Grading Plan
Scale: 1"=30'

Popeyes Chicken & Biscuits Restaurant
JUAN TABO NE AT LEXINGTON AVENUE NE, ALBUQUERQUE, NEW MEXICO

SHEET NO.
C.2

SHEET NO.	C.2
RECEIVED	
DEC 27 2006	
HYDROLOGY SECTION

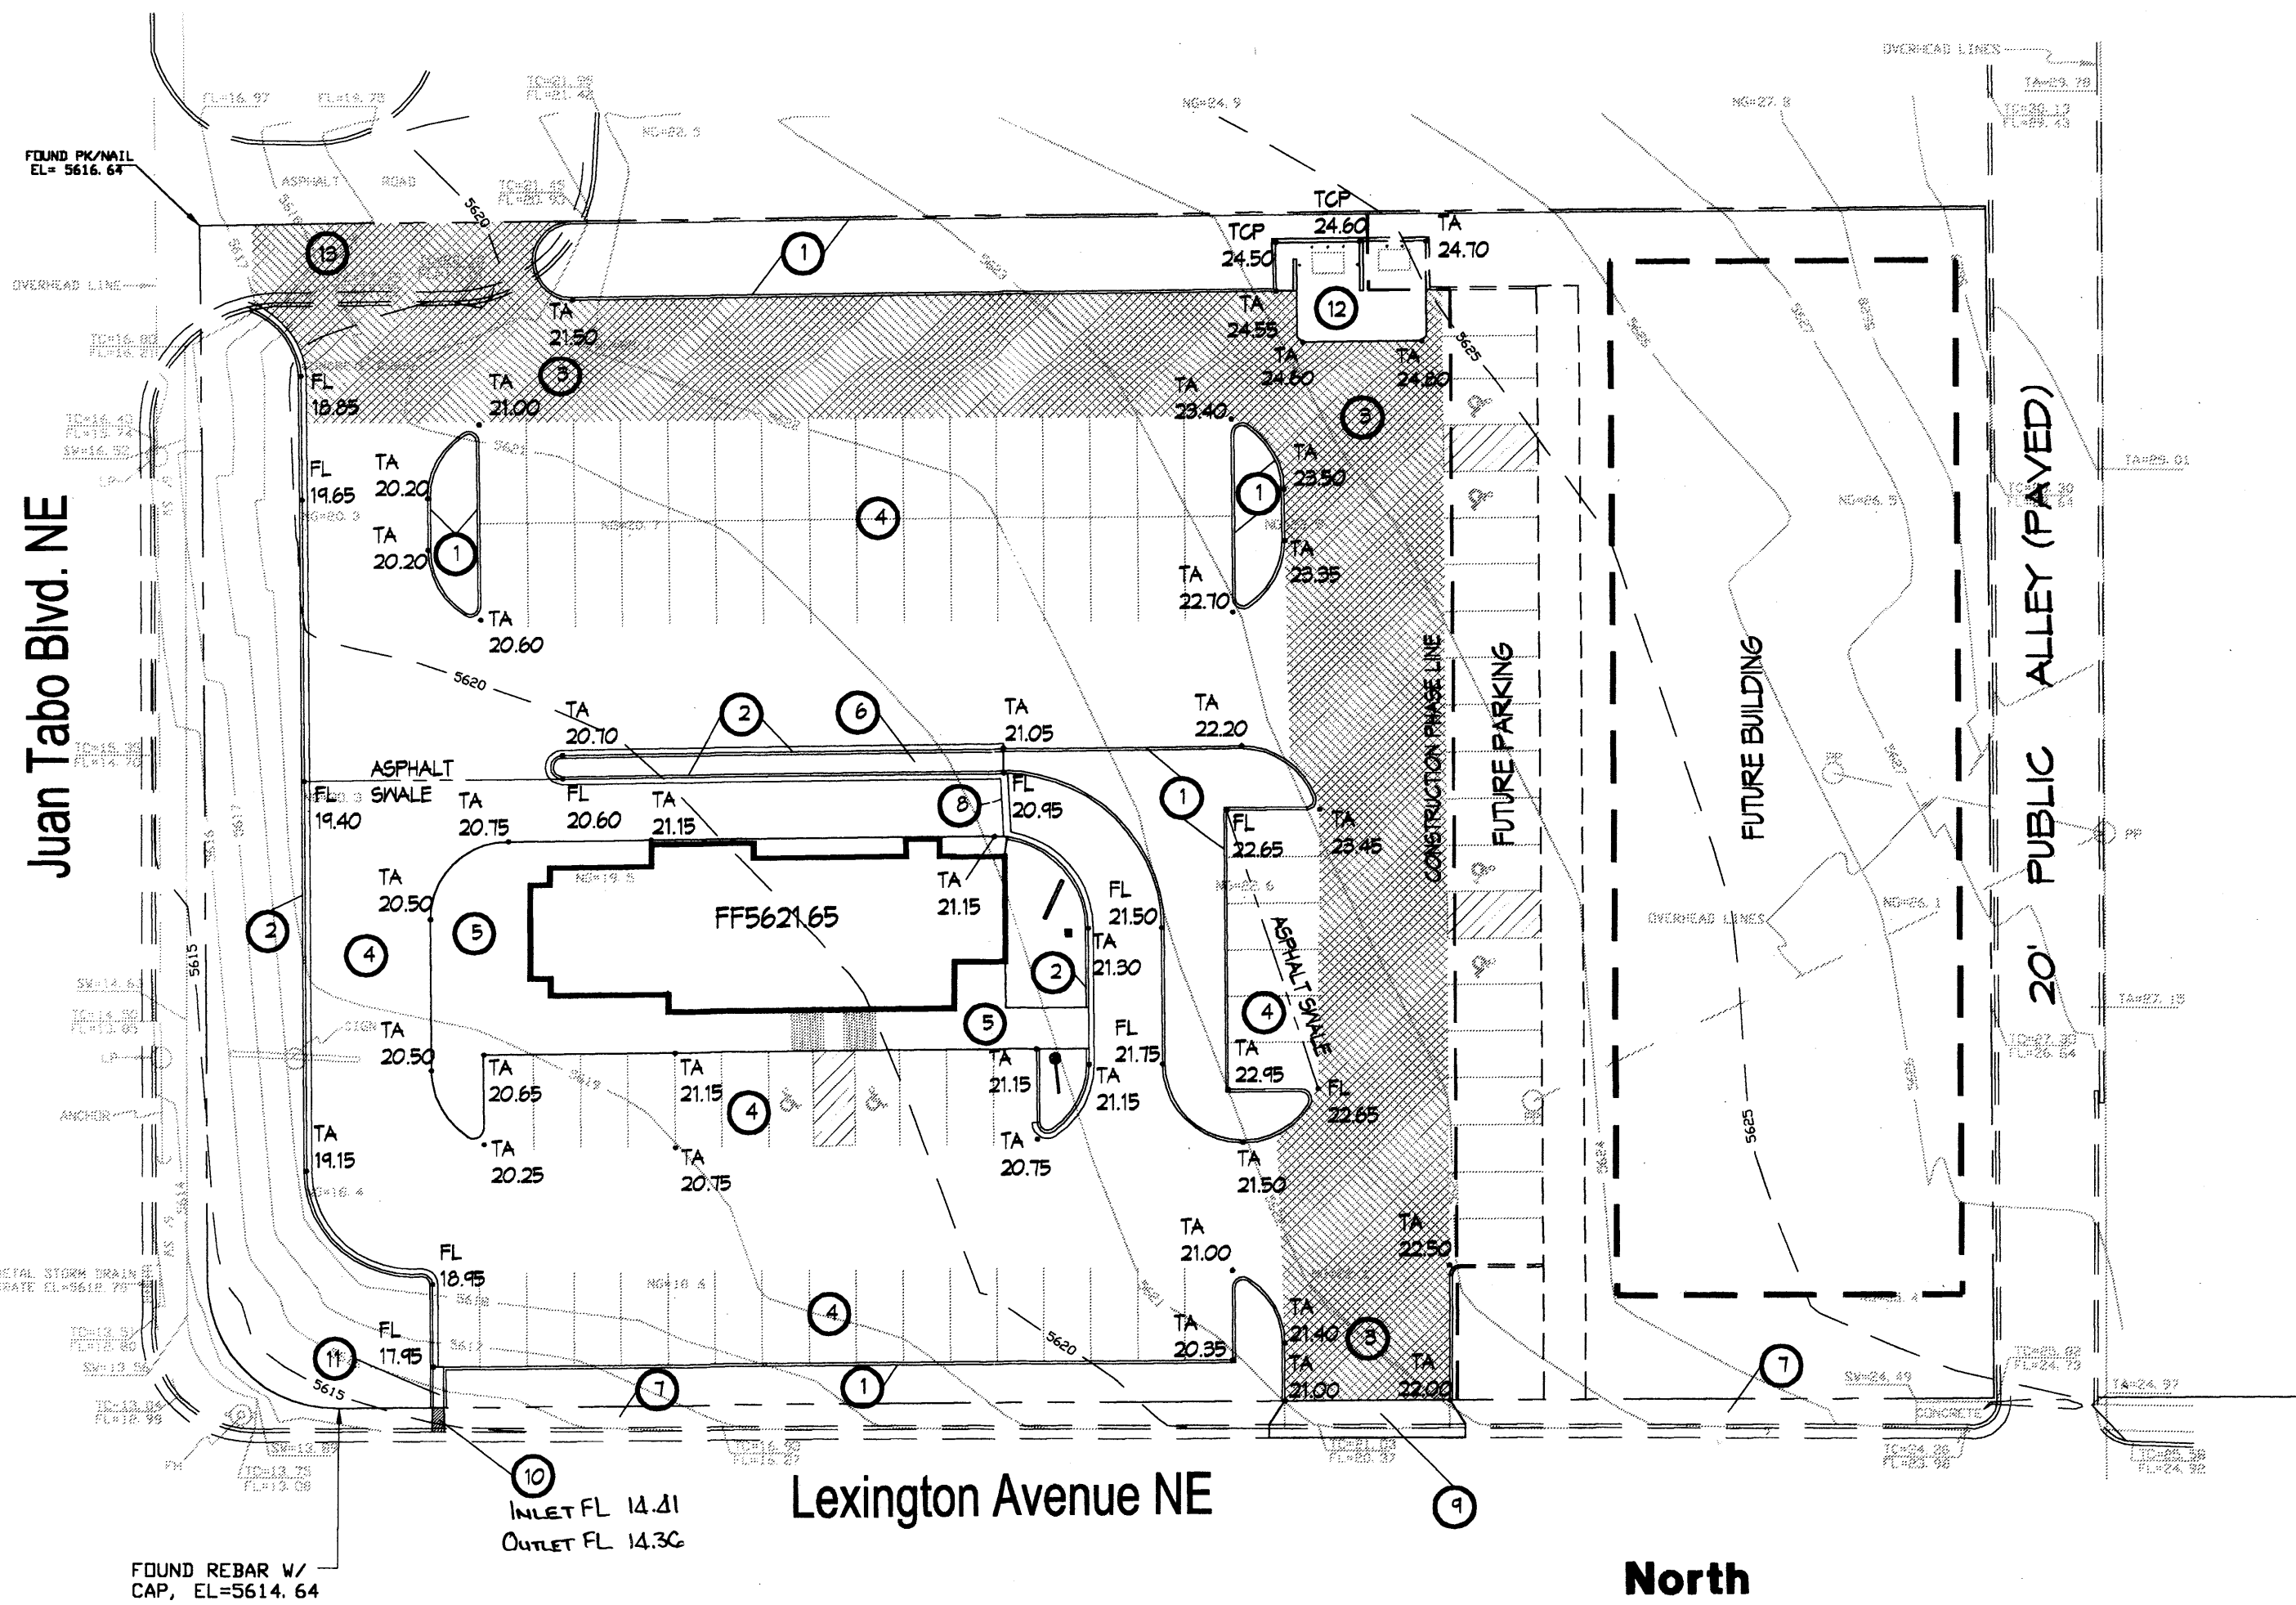
I, JEAN J. BORDENAVE, NMPE&LS NO. 5110, OF THE FIRM BORDENAVE DESIGNS, HEREBY CERTIFY THAT THIS PROJECT HAS BEEN GRADED AND WILL DRAIN IN ACCORDANCE WITH THE DESIGN INTENT OF THE APPROVED PLAN DATED OCTOBER 04/06. THE RECORD INFORMATION EDITED ONTO THE ORIGINAL DESIGN DOCUMENT HAS BEEN OBTAINED BY ME OR UNDER MY DIRECT SUPERVISION AND IS TRUE AND CORRECT TO THE BEST OF MY KNOWLEDGE AND BELIEF. THIS CERTIFICATION IS SUBMITTED IN SUPPORT OF A REQUEST FOR A TEMPORARY CERTIFICATE OF OCCUPANCY.

EXCEPTION:
OUTLET CHANNEL & SIDEWALK CULVERT UNDER CONSTRUCTION
